Source: TSG CN WG 1
Title: CRs to R99 (with mirror CRs) on Work Item TEI towards 24.008
Agenda item: 7.11
Document for: APPROVAL

This document contains 9 CRs on R99 including mirror CRs to Work Item "TEI", that have been agreed by TSG CN WG1, and are forwarded to TSG CN Plenary meeting #17 for approval.

Title:	⌘ Routing Area Update at network change		
Source:	⌘ Orange France, Siemens AG		
Work item code:	⌘ TEI	Date:	⌘ 22/07/2002
Category:	⌘ F	Release:	⌘ R99
	Use <u>one</u> of the following categories:		Use <u>one</u> of the following releases:
	F (correction)		2 (GSM Phase 2)
	A (corresponds to a correction in an earlier release)		R96 (Release 1996)
	B (addition of feature),		R97 (Release 1997)
	C (functional modification of feature)		R98 (Release 1998)
	D (editorial modification)		R99 (Release 1999)
	Detailed explanations of the above categories can be found in 3GPP TR 21.900.		Rel-4 (Release 4)
			Rel-5 (Release 5)
			Rel-6 (Release 6)

Figure 4.1b/3GPP TS 24.008:GMM main states in the MS

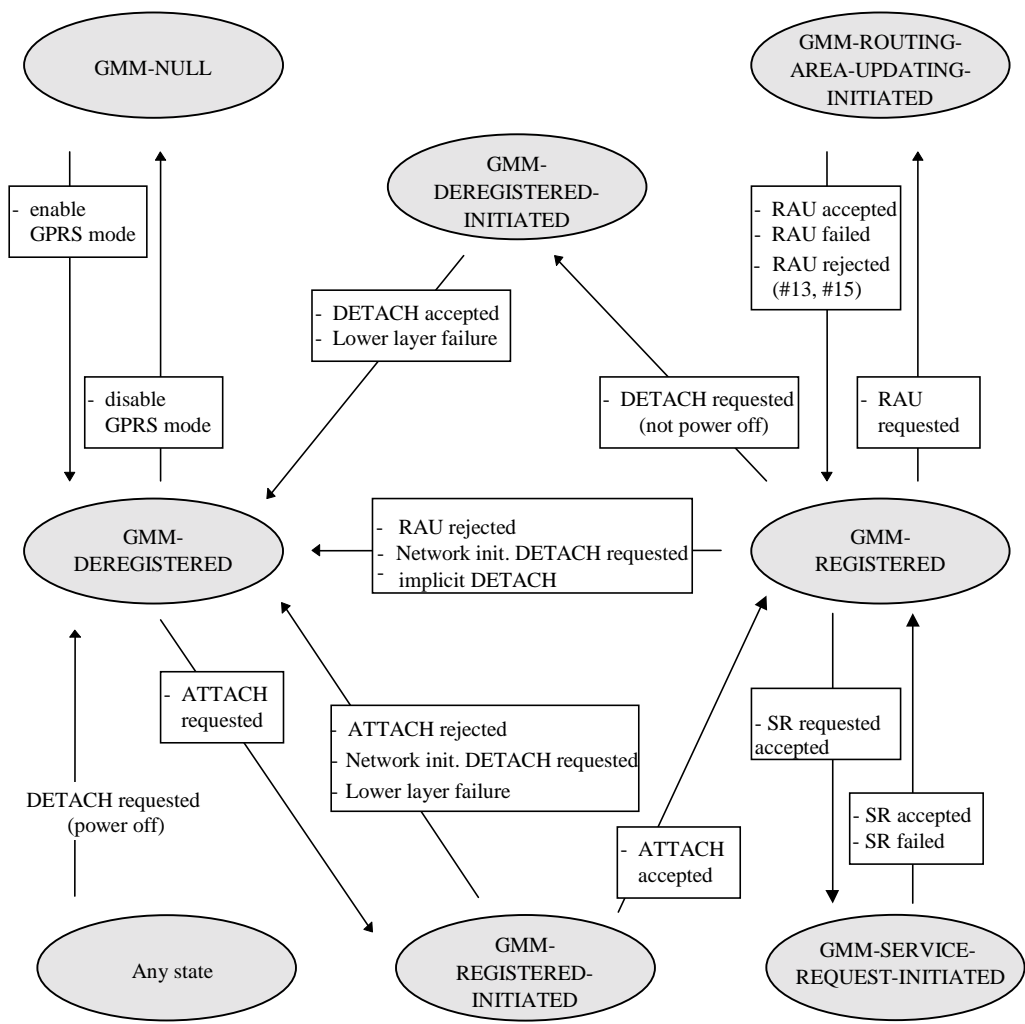
Reason for change:	⌘ Currently, in TS24.008 the behaviour of an MS attached to the packet domain is not clear when entering a new PLMN. CR 275rev2 on TS23.060 (included in SP-010706 – SA#14) clarified that Routing Area Update procedure shall be performed in such a case (and not Attach procedure). <u>This CR also includes correction and missing information in the current version of the specification regarding the GMM-REGISTERED.PLMN-SEARCH with is mentioned and not defined.</u>
Summary of change:	⌘ It is indicated that, to trigger the normal routing area updating to update the registration of the actual routing area of an MS in the network, the new routing area can belong to the same PLMN as the old routing area or not. <u>Corrections and missing information:</u> <ul style="list-style-type: none"> - in §4.7.5.1.5, GMM-REGISTERED.PLMN-SEARCH is mentioned but is not defined (definition added in §4.1.3.1.3 and in §4.2.5.1) - in §4.7.5.1.5, reference to GMM-REGISTERED.PLMN-SEARCH section is corrected, bullet before ' If the routing area updating attempt counter is greater than or equal to 5:' is removed (not the text, just the bullet) - when the maximum number of RAU attempts is reached the MS shall go to PLMN-SEARCH substate within the GMM-REGISTERED state and not within the GMM-DEREGISTERED state as defined currently.

Figure 4.1b/3GPP TS 24.008:GMM main states in the MS

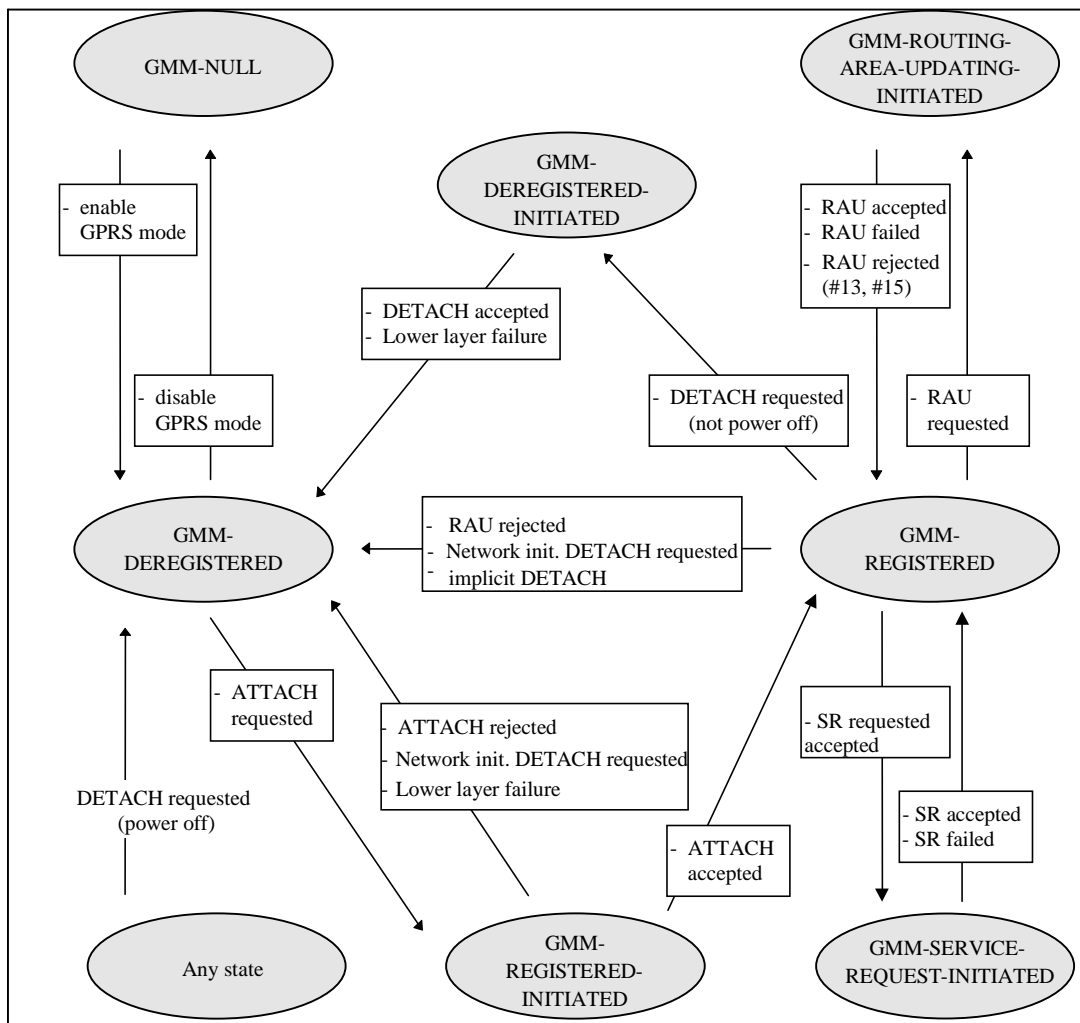
Reason for change:	⌘ Currently, in TS24.008 the behaviour of an MS attached to the packet domain is not clear when entering a new PLMN. CR 275rev2 on TS23.060 (included in SP-010706 – SA#14) clarified that Routing Area Update procedure shall be performed in such a case (and not Attach procedure).
	<u>This CR also includes correction and missing information in the current version of the specification regarding the GMM-REGISTERED.PLMN-SEARCH with is mentioned and not defined.</u>
Summary of change:	⌘ It is indicated that, to trigger the normal routing area updating to update the registration of the actual routing area of an MS in the network, the new routing area can belong to the same PLMN as the old routing area or not.
	<p><u>Corrections and missing information:</u></p> <ul style="list-style-type: none"> - <u>in §4.7.5.1.5, GMM-REGISTERED.PLMN-SEARCH is mentioned but is not defined (definition added in §4.1.3.1.3 and in §4.2.5.1)</u> - <u>in §4.7.5.1.5, reference to GMM-REGISTERED.PLMN-SEARCH section is corrected, bullet before ' If the routing area updating attempt counter is greater than or equal to 5:' is removed (not the text, just the bullet)</u> - <u>when the maximum number of RAU attempts is reached the MS shall go to PLMN-SEARCH substate within the GMM-REGISTERED state and not within the GMM-DEREGISTERED state as defined currently.</u>

Figure 4.1b/3GPP TS 24.008:GMM main states in the MS

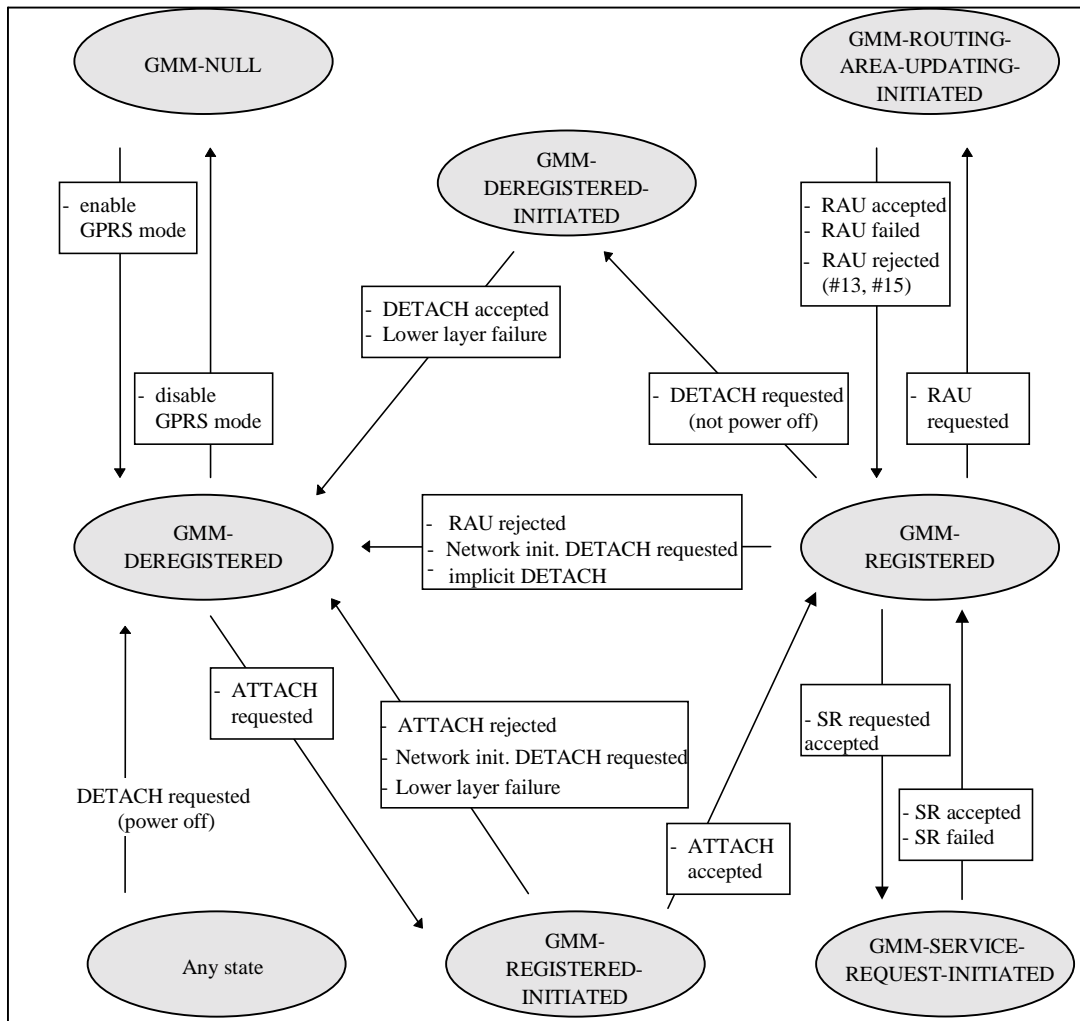
Reason for change:	⌘ Currently, in TS24.008 the behaviour of an MS attached to the packet domain is not clear when entering a new PLMN. CR 275rev2 on TS23.060 (included in SP-010706 – SA#14) clarified that Routing Area Update procedure shall be performed in such a case (and not Attach procedure). This CR also includes correction and missing information in the current version of the specification regarding the GMM-REGISTERED.PLMN-SEARCH with is mentioned and not defined.
Summary of change:	⌘ It is indicated that, to trigger the normal routing area updating to update the registration of the actual routing area of an MS in the network, the new routing area can belong to the same PLMN as the old routing area or not. <u>Corrections and missing information:</u> - in §4.7.5.1.5, GMM-REGISTERED.PLMN-SEARCH is mentioned but is not defined (definition added in §4.1.3.1.3 and in §4.2.5.1) - in §4.7.5.1.5, reference to GMM-REGISTERED.PLMN-SEARCH section is corrected, - when the maximum number of RAU attempts is reached the MS shall go to PLMN-SEARCH substate within the GMM-REGISTERED state and not within the GMM-DEREGISTERED state as defined currently.
